**RE: Value Engineering - Paved Ditch
Rt I-44 Newton Cty
Job J7I0691**

VALUE ENGINEERING CHANGE PROPOSAL MISSOURI DEPARTMENT OF TRANSPORTATION

Contract ID 120525-G01 Job No. J7I0691

ROUTE	I-44	STATE	MO
DISTRICT	SW	SHEET NO.	6
COUNTY	NEWTON		
JOB NO.	J710691		
CONTRACT ID.			
PROJECT NO.			
BRIDGE NO.

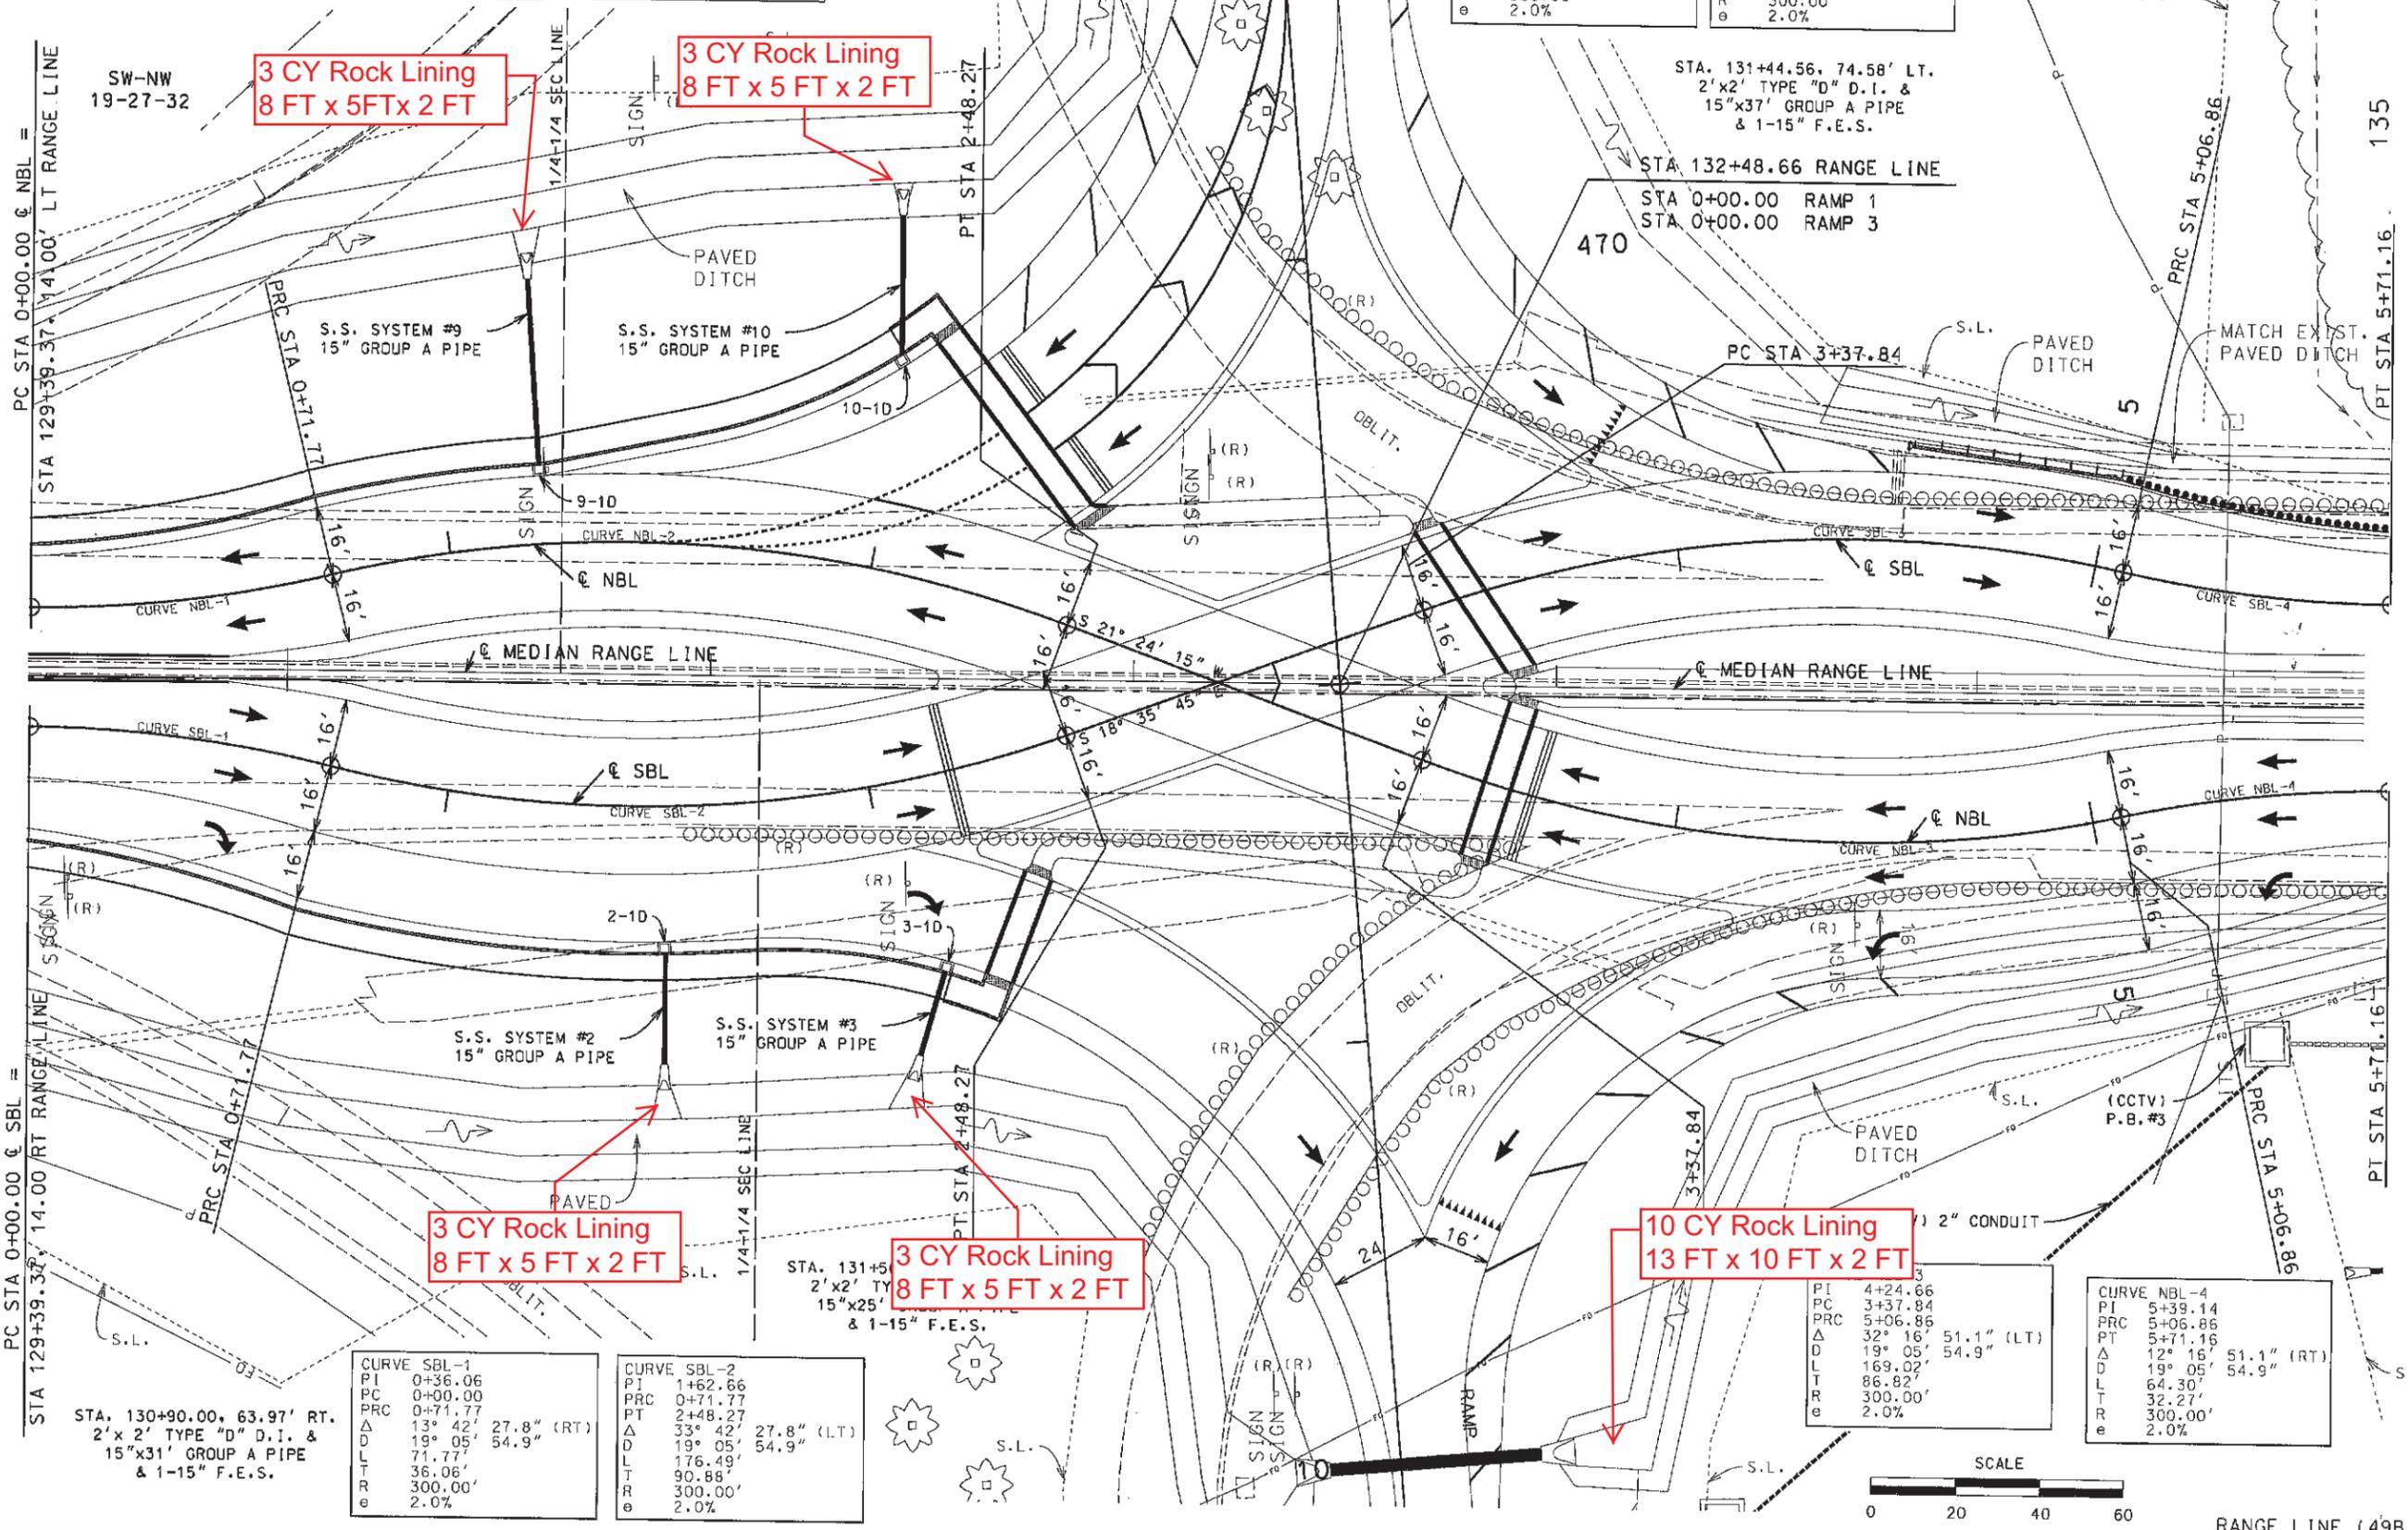
The existing design calls for the construction of Paved Ditch on both sides of Rangeline Road and Ramps 1 & 3. We would like to propose the replacement of all of the Paved Ditches on the North Side of I-44 with a combination of Turf Reinforcing Mat and Rock Lining. Current conditions allow vegetation to handle all run off with little to no erosion issues. The replacement of Paved Ditches with a Type 3 Turf Reinforcing Mat and Rock lining will increase the amount of permanent vegetation as well as overall permeable area on the project. This increase in vegetation will also help reduce runoff velocities which contributes to negative impacts on downstream property.

3 CY Rock Lining
8 FT x 5 FT x 2 FT

3 CY Rock Lining
8 FT x 5 FT x 2 FT

The Joplin RE office recommends approval of this VE based on reviews from design and our environmental group. The Type 3 TRM proposed handles the shear stresses calculated by our design group on this project. In addition, paved ditches typically result in downstream degradation problems due to too much velocity and they allow for zero infiltration. In addition, many we currently have in our system are undercut and caving in. If the TRM is installed correctly, mowers should have no problems traversing it. We recommend approval of this VE on a 50/50 basis. In addition, this will save time and money.
